Economic Commission for Europe**Inland Transport Committee****World Forum for Harmonization of Vehicle Regulations****Working Party on Passive Safety****Sixty-fifth session**

UN Regulation No. 129 (Enhanced Child Restraint Systems)**Proposal for Supplement 3 to the 03 series of amendments to
UN Regulation No. 129****Submitted by the expert from the European Association of Automotive
Suppliers***

Universal booster cushion

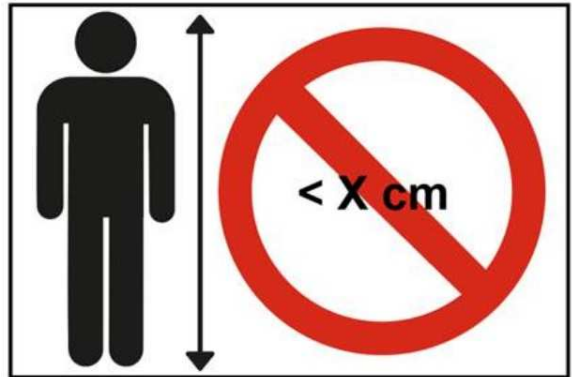
"4.8.3. **Universal booster cushion Enhanced Child Restraint Systems shall have a permanently attached label with the following information visible to the person installing the Enhanced Child Restraint System in the car:**

Figure 1
Measurement device to check the Sitting Height

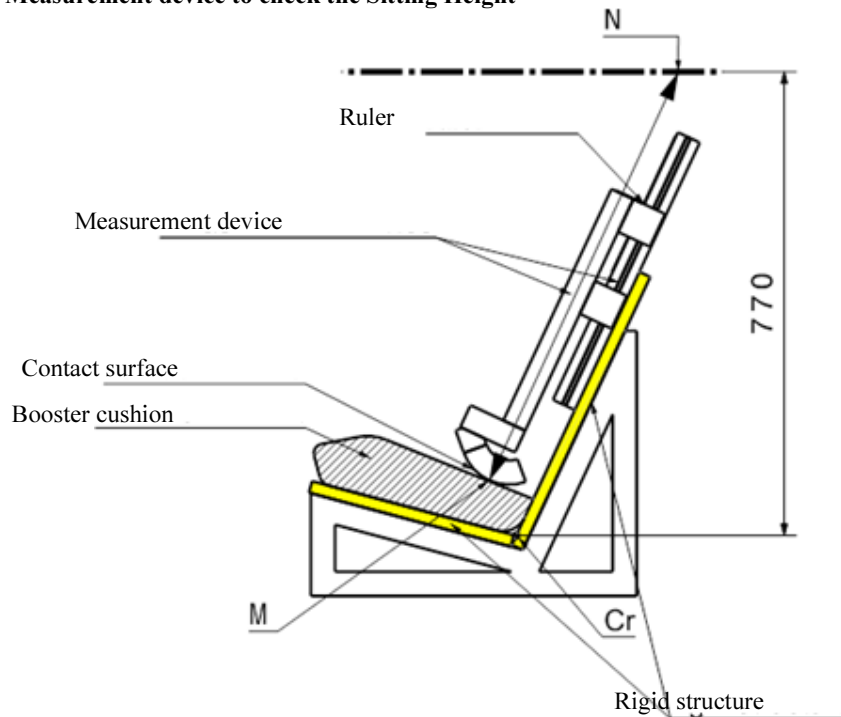
"6.1.3.6 **For booster cushions, type approval shall not be granted for a stature below 125 cm. Booster cushions shall not be declared for use below a stature of 125 cm.**

Booster cushions shall ensure that the top of the child's head is at or above a horizontal plane at 770 mm vertically from the Cr axis when seated on the test bench described in Annex 6.

The procedure to check if a booster cushion fulfils this requirement is outlined as follows (See figure 1 below):

- (a) A simulated test bench shall be used for the assessment. The simulated bench shall have the same geometry as the test bench defined in Annex 6 of this Regulation, including the seat cushions. However, the width of the simulated bench may be reduced, if the width is* between 500 and 800 mm, as shown in Annex 25. The simulated test bench shall be of rigid construction and shall not deform when using the measuring device defined in Annex 25.

- (b) A rigid structure is attached to the simulated test bench and holds a sliding part. A horizontal plane that is located at a vertical distance of 770 mm from the Cr axis is defined.

- (c) The booster cushion shall be placed on the simulated test bench with its centreline aligned with the centreline of the test bench and the rear surface of the booster cushion contacting the backrest of the test bench.

- (d) If ISOFIX attachments are present these shall be latched with the test bench lower ISOFIX anchorages. An additional force of 135 +/- 15N shall be applied in a plane parallel to the surface of the simulated test bench. The force shall be applied along the centreline of the Enhanced Child Restraint System and at a height of no more than 100 mm above the simulated test bench seat surface.

- (e) The measurement device is extended downwards parallel to the simulated test bench backrest, until it is stopped by the booster seat cushion.

Figure 2
Ruler of measurement device

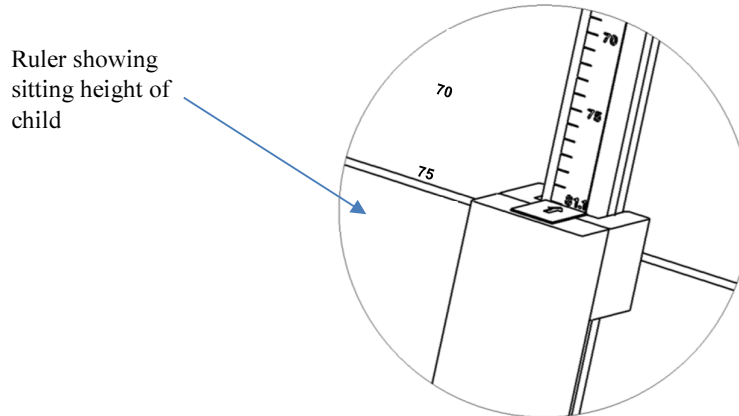
- (f) The measured distance between the two points M and N (Figure 1) represents the sitting height of a child who will use the booster cushion. The corresponding value is displayed by a ruler that is provided with the device as shown in Figure 2.
- (g) Using the data in Table 3, the sitting height is utilized to determine the corresponding minimum stature of the child that can be accommodated by the booster cushion. Example: A sitting height of 66.2 cm shall correspond to a child minimum stature of 125 cm; a sitting height of 75.9 cm shall correspond to 150 cm.

In case the value obtained for the sitting height is between two integer values always round up to the next integer value (e.g. Measured sitting height = 70.1 cm ► resulting stature = 135.65 cm ► Smallest stature allowed = 136 cm).

- (h) The stature determined in this procedure shall be compared to the lower limit of the approval stature range. The requirement is fulfilled if the lower approval stature is greater or equal than the obtained minimum stature.

1. Arrangements of the approval mark

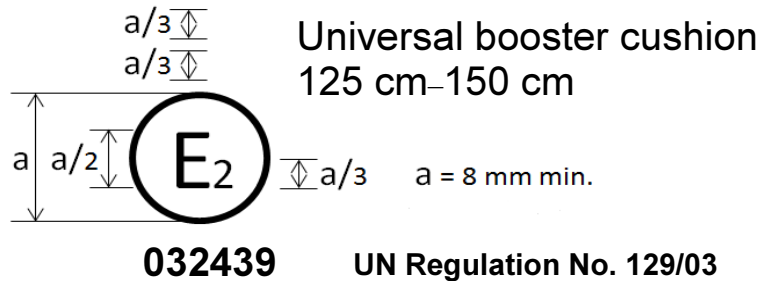
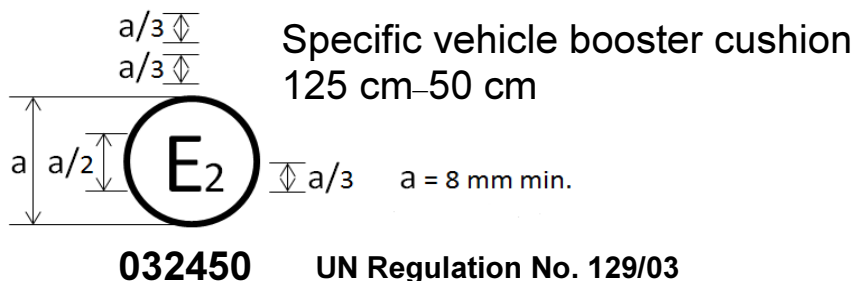
The Enhanced Child Restraint System bearing the above approval mark can be fitted in any i-Size seating position and Universal seating position, and used for the 125 cm–150 cm size range; it is approved in France (E 2) under the number 032439. The approval number indicates that the approval was granted in accordance with the requirements of the Regulation concerning the approval of Enhanced Child Restraint Systems used on-board of motor vehicles as amended by the 03 series of amendments. In addition, the name of the Regulation is to be identified on the approval mark followed by the series of amendment according to which the approval has been granted.

The Enhanced Child Restraint System bearing the above approval mark is a device not capable of being fitted in every vehicle but is capable of being used for the 125 cm–150 cm size range; it is approved in France (E 2) under the number 032450. The approval number indicates that the approval was granted in accordance with the requirements of the Regulation concerning the approval of specific vehicle booster cushion Enhanced Child Restraint Systems used on-board of motor vehicles as amended by the 03 series of amendments. In addition, the name of the Regulation needs to be identified on the approval mark followed by the series of amendment according to which the approval has been granted.

Device to measure the booster cushion height

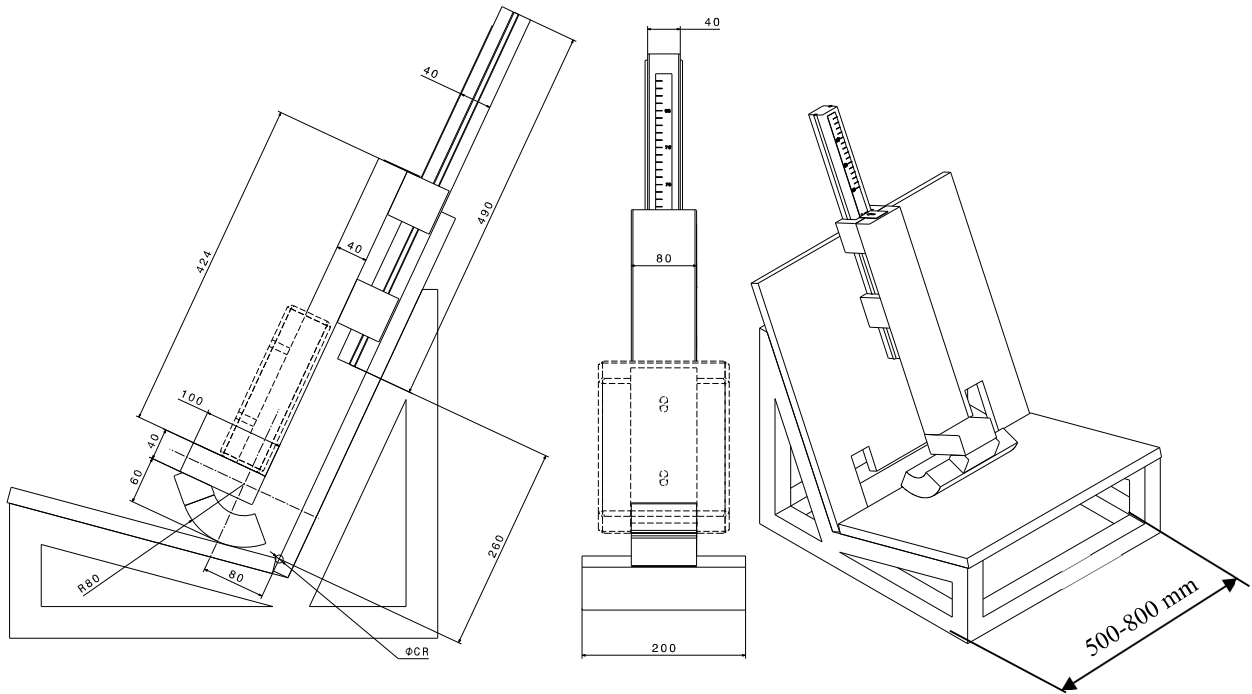
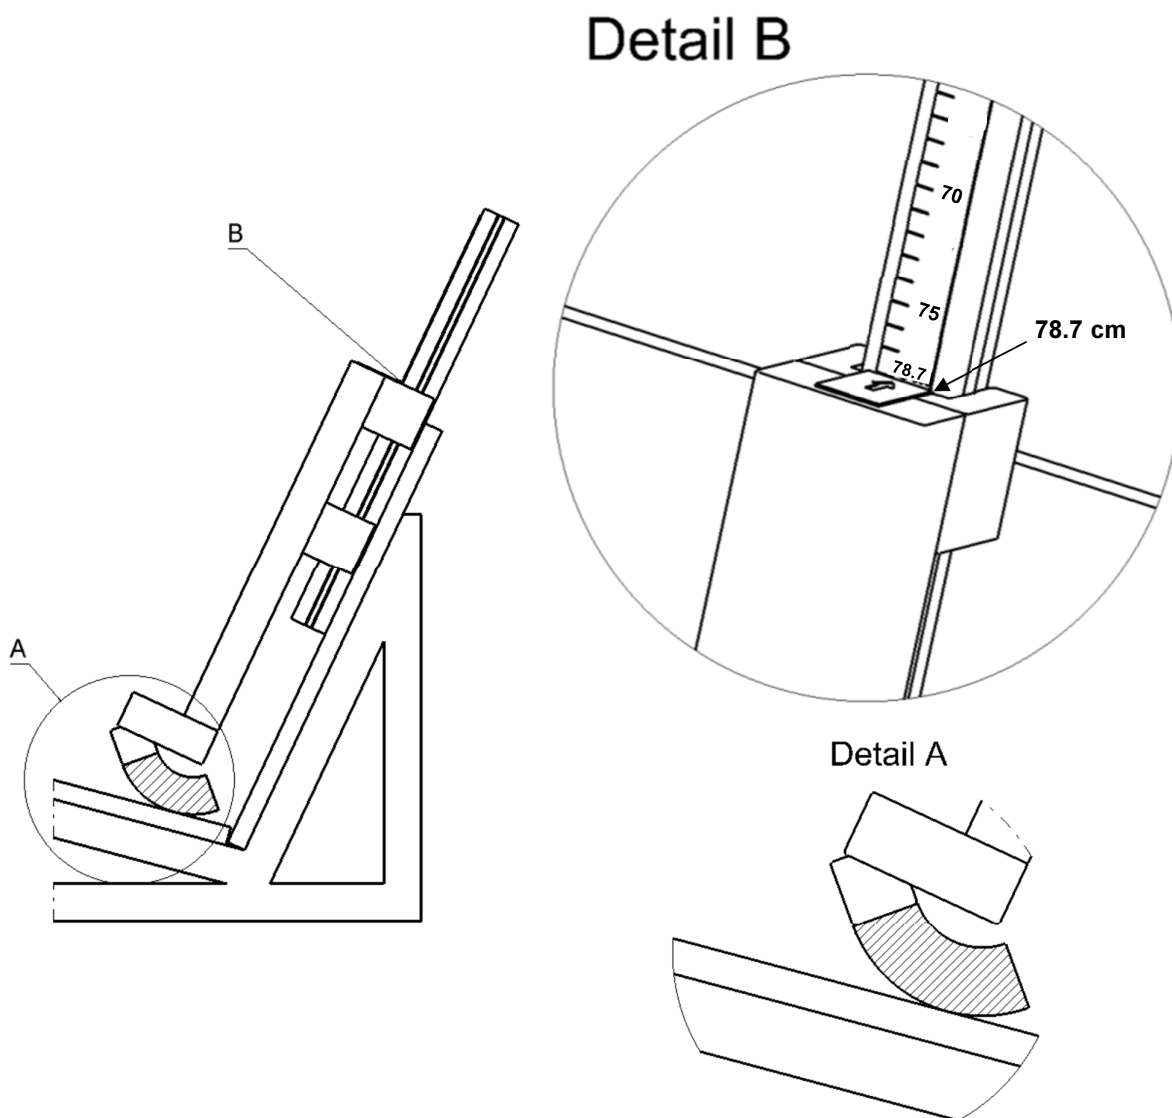
The mass of the device shall be 15kg +/-1kg

To calibrate the ruler of the measurement device, its structure shall contact the supporting surface (Detail A). In this configuration, the scale shall show the calibration value of 78.7 cm (Detail B).

The calibration of the ruler is based on the sitting height of the Hybrid III 5th percentile dummy seated on the test bench defined in Annex 6 of this Regulation. When this dummy is seated on the test bench, the top of the head is 77.0 cm from the Cr axis. The nominal sitting height of the dummy is 78.7 cm. Therefore, 78.7 cm is used as the calibration value.

Figure 1
Manikin block (based on truncated P10)
Material: Expanded polystyrene (EPS) (40 to 45 g/l)

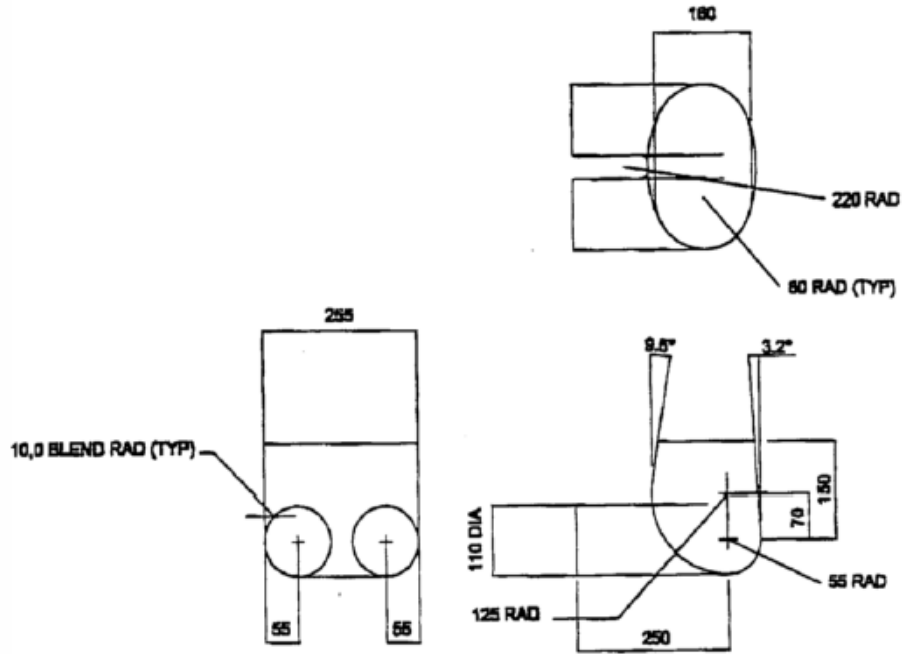
Place a cotton cloth on the seating surface of the test bench. Position the booster cushion on the test bench, position the lower torso body block as described in Annex 26, Figure 1, on the seating surface, fit and apply the 3-point adult safety-belt and tension as prescribed in paragraph 7.1.3.5.2.2. With a strip of 25 mm-wide webbing or similar, tied around the booster, apply a load of 250 ± 5 N in the direction of arrow A (see Annex 26, Figure 2), in line with the seating surface of the test bench.

The booster cushion shall not be pulled completely out of the 3-point adult safety-belt and shall remain under the body block during the test."
